We thank the Editor for requesting we re-submit a revised manuscript addressing the Reviewer's comments and suggestions. Please see below the details of our modifications in the revised manuscript.

Short Comment 1

Referee comment 1

Referee comment 2

5 **Figure 1** State of Victoria, Australia, mean annual rainfall for AWAP for 1990-2009 (legend shows mm/yr) and location of study catchments used for rainfall-runoff modelling

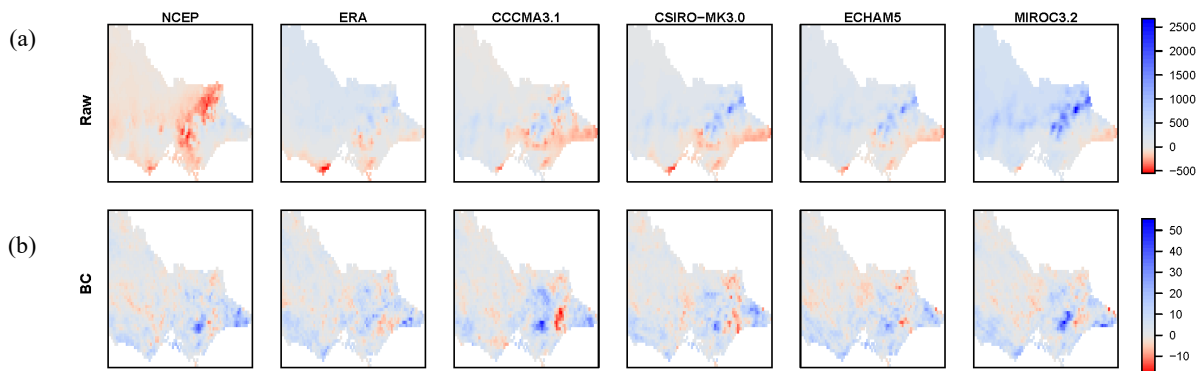
13. Figure 1. You can add the legend title (i.e. annual mean rainfall (mm/yr))

Figure caption includes the legend title.

Figure 8 Distributed (horizontal axis) versus Lumped (vertical axis) change (future period relative to current period) in mean annual runoff (%). Orange = CCCMA3.1; yellow = CSIRO Mk3.0; Dark blue = ECHAM5; Light blue = MIROC3.2

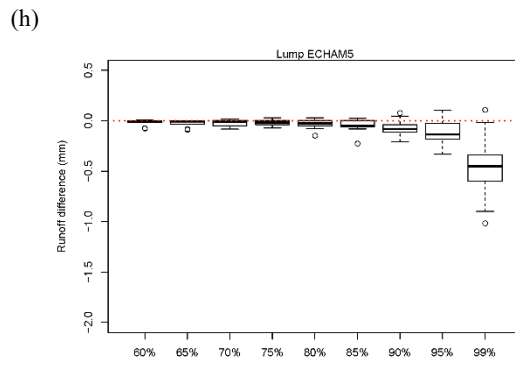
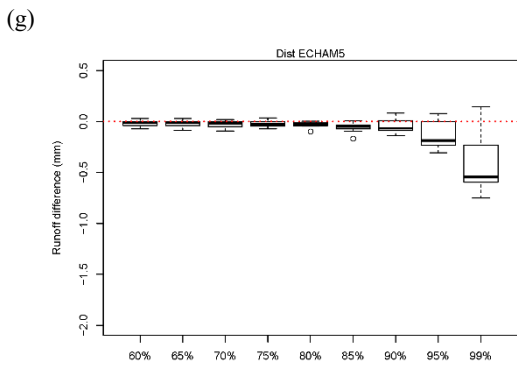
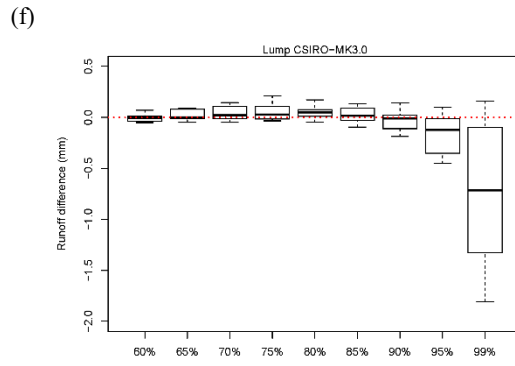
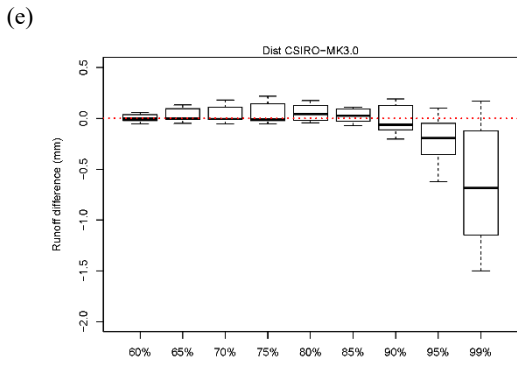
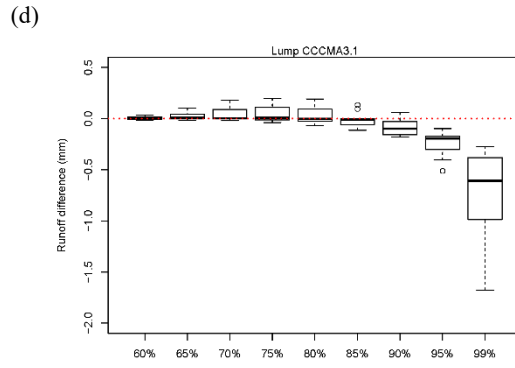
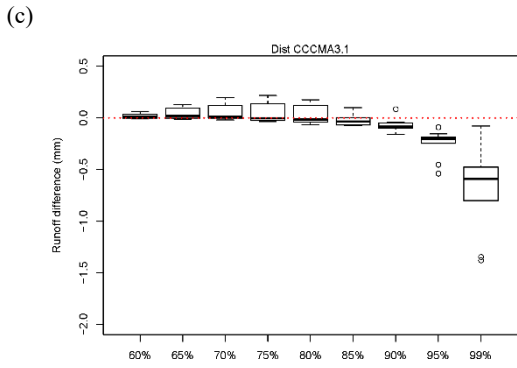
5. In Figure 8 the percent of the projected change in the runoff is presented. This analysis could be augmented by showing the transition of the percent change from the GCM, raw-WRF, BC-WRF, raw runoff and BC runoff. In the current analysis, the differences in changes are mainly attributed to the selection of the GCM, and the contribution of the BC is unclear.

Referring to rainfall, we do not use GCM rainfall and so cannot show “the percent change from the GCM”; we do show the raw and BC WRF rainfall change in Figure 4. For runoff, because of the biases in raw WRF rainfall, it does not make sense to show the runoff change that results from using raw WRF rainfall.

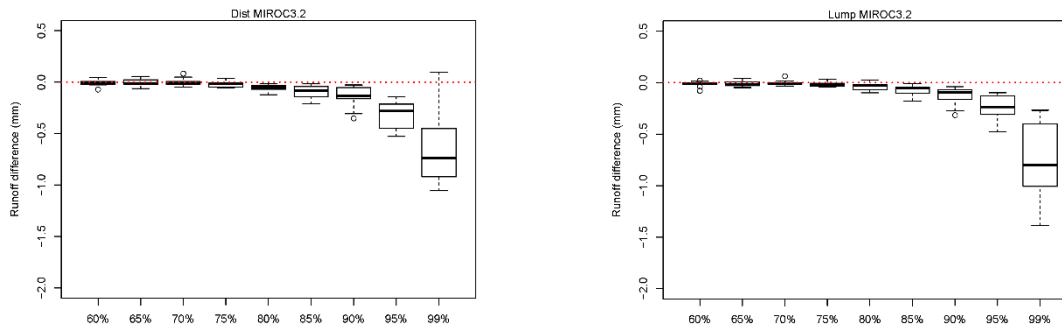
14. Figure 9. Add the title of the y axis title.

Do you mean x-axis title, as the y-axis are all labelled? We have modified the figure caption to make it clear we are showing high flow percentiles for the 60 to 99 percentiles.
